ADDENDUM NO. 1 TO PROJECT NO. 44800

**REHABILITATE WEST ENTRANCE & BASEMENT AREAS
TONAWANDA INDIAN COMMUNITY HOUSE
372 BLOOMINGDALE ROAD
AKRON, NY**

January 15, 2015

SHEET TITLE: **UPDATED PLAYGROUND SURFACING**

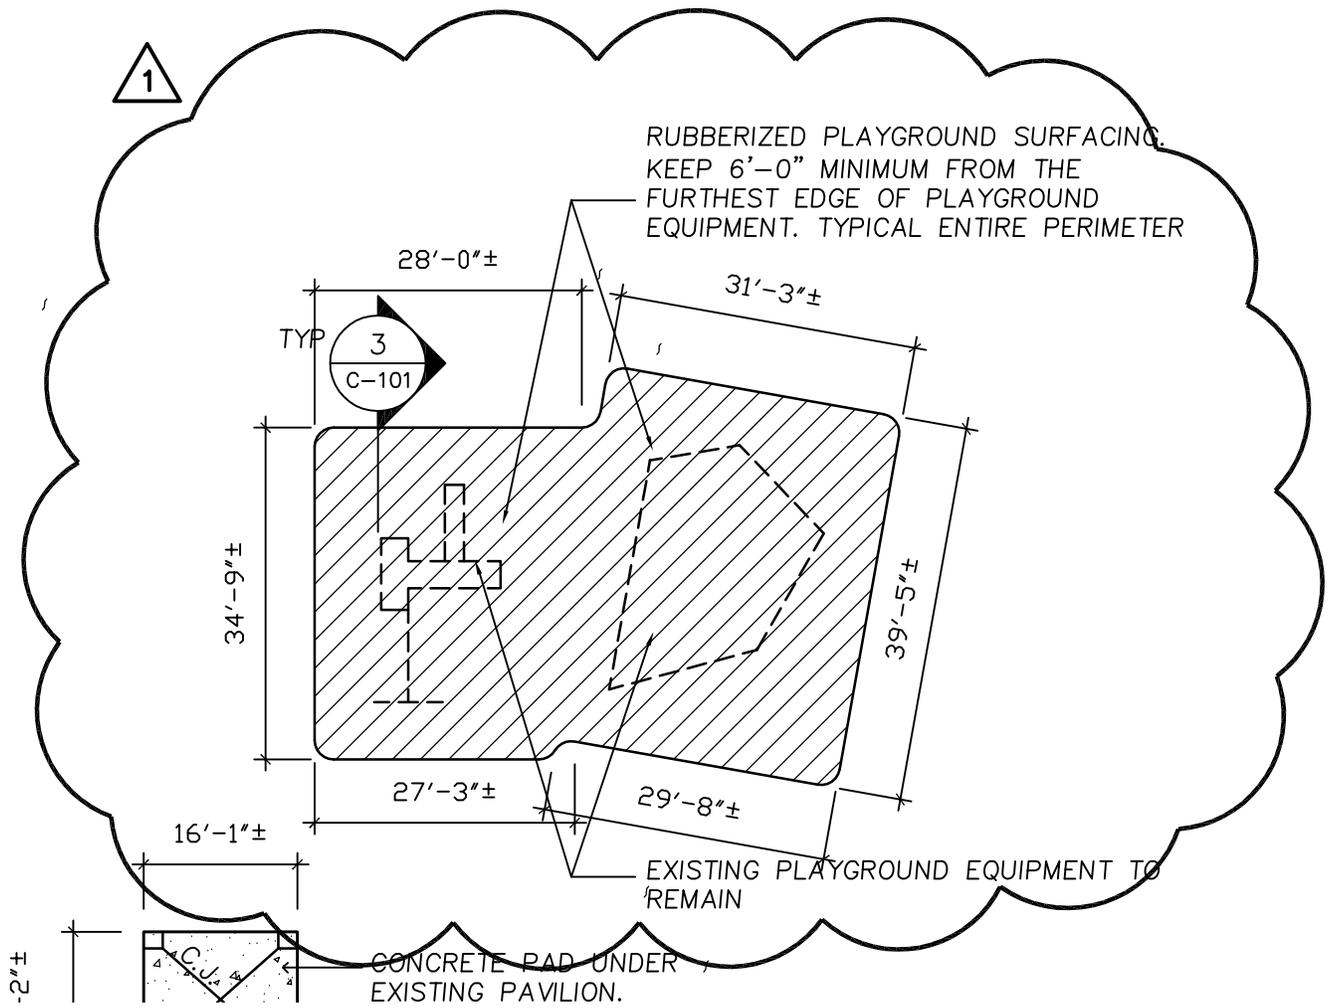
1. DRAWING C-101:
 - a. Drawing SK-01, titled "UPDATED PLAYGROUND SURFACING" accompanies this Addendum and supersedes the playground surfacing plan as shown on the Site Plan in the originally issued drawing C-101.

RUBBERIZED PLAYGROUND SURFACING.
KEEP 6'-0" MINIMUM FROM THE
FURTHEST EDGE OF PLAYGROUND
EQUIPMENT. TYPICAL ENTIRE PERIMETER
